# Site Plan Review Committee (SPRC) Staff Report for Arva (2201 Arlington Blvd)

**Item 1. SPLN22-00006**  
(RPC# 18-059-020)  
Planning Commission and County Board meetings to be determined.  
*Peter Schulz (CPHD Staff)*

**Arva SPLN22-00006**  
(RPC# 18-059-020)

Figure 2-- Ground plan, courtesy applicant

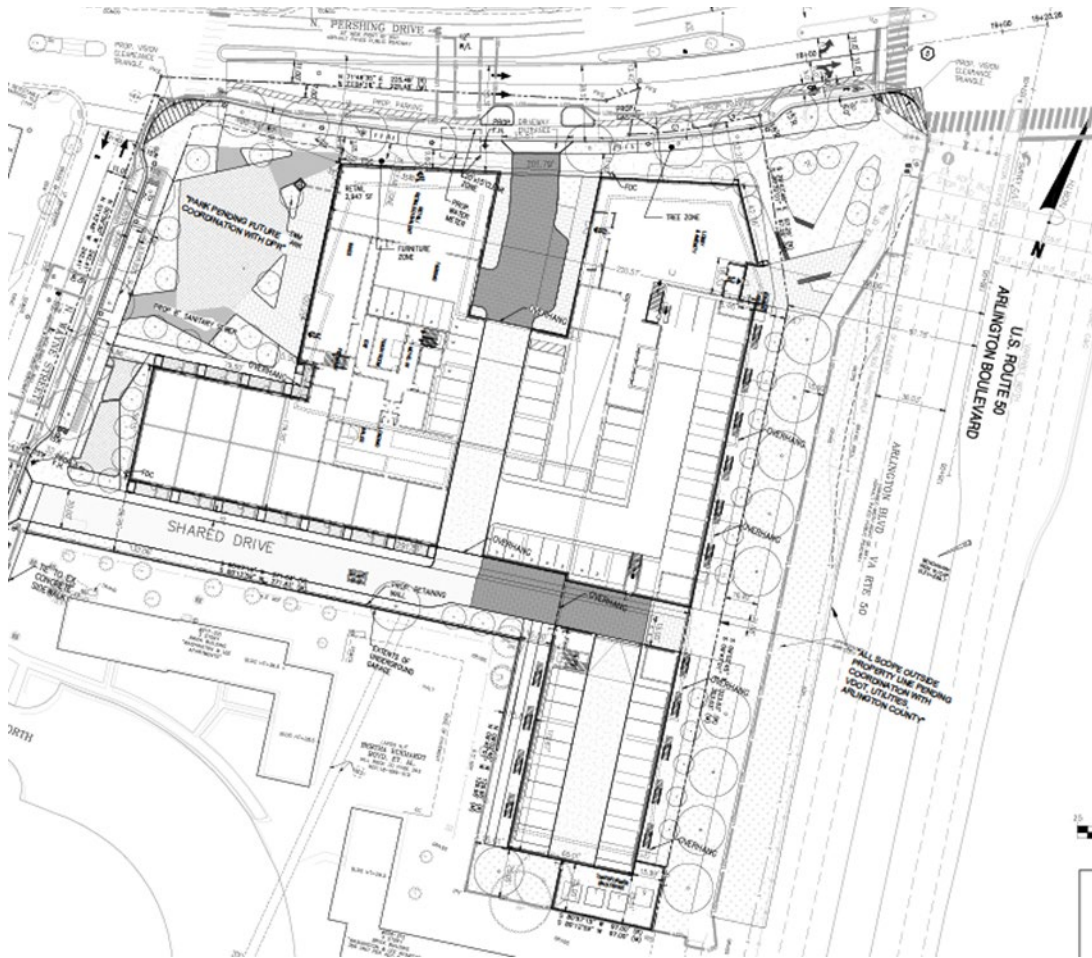
- Architecture/Urban Design: Areas of above grade parking create occasional blank walls and awkward urban design;
- Architecture/Urban Design: The architecture, especially above the second level, does not do enough to either reference the mid-Century architecture of the existing motel, nor the colors and architectural vocabulary of the earlier Washington-Lee Apartments.

- Public Space/Landscaping: The proposed public space includes areas for internal pedestrian site circulation and is also immediately adjacent to the retail space.

- Public Space/Landscaping: The proposed areas for the electrical transformers, while underground, create an area adjacent to both the Washington-Lee Apartments and the Arlington Boulevard façade that cannot be planted.

- Public Space/Landscaping: Landscaping does not entirely meet the recommendations of the GLUP Study document, especially on the south property line.
- Public Space/Landscaping: Can the proposed private dog run be moved elsewhere on the property? As proposed, it may need a taller fence to prevent dogs from escaping, which would have negative effect on the streetscape and the pedestrian experience walking on that side of North Wayne Street. It would also permit dwelling units adjacent to it to have windows or door openings onto that side of the façade. A dog run at an upper level of the building might also be easier for the building owner to treat waste and install AstroTurf for easier cleaning.
